# PERMIT

SEWAGE DISPOSAL SYSTEM

SUBDIVISION \_\_\_\_\_ ROAD 4335 Roxbury Mill Rd. LOT \_\_\_\_\_

PROPERTY OWNER Robert P. Buice

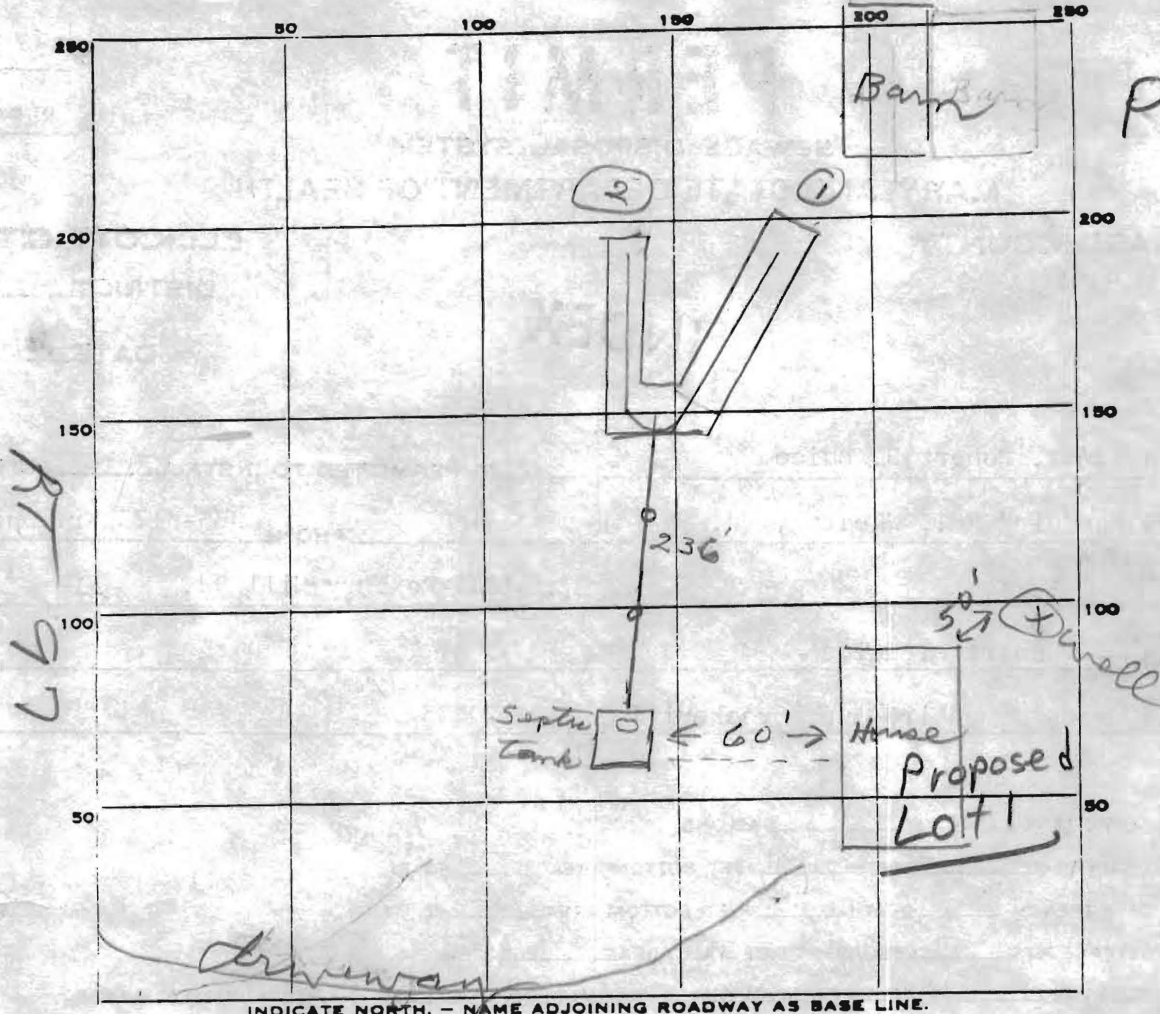
Enclosed is a copy of the sketch and observations made by James Stayer of this office on February 11, 1982 indicating a sewage overflow in the area shown.

As this office has no record of the existing septic system, and whatever system that is there is malfunctioning, correction of the existing problem at the existing house is mandatory, if the house is to be occupied. If the house is to be removed a suitable percolation test area must also be found, and the existing well site must be identified.

Two (2) 25 ft trenches, 6 ft deep inlet 2-3 ft with 3 ft of stone. Start trenches 230 ft from septic tank along side & above corn field.
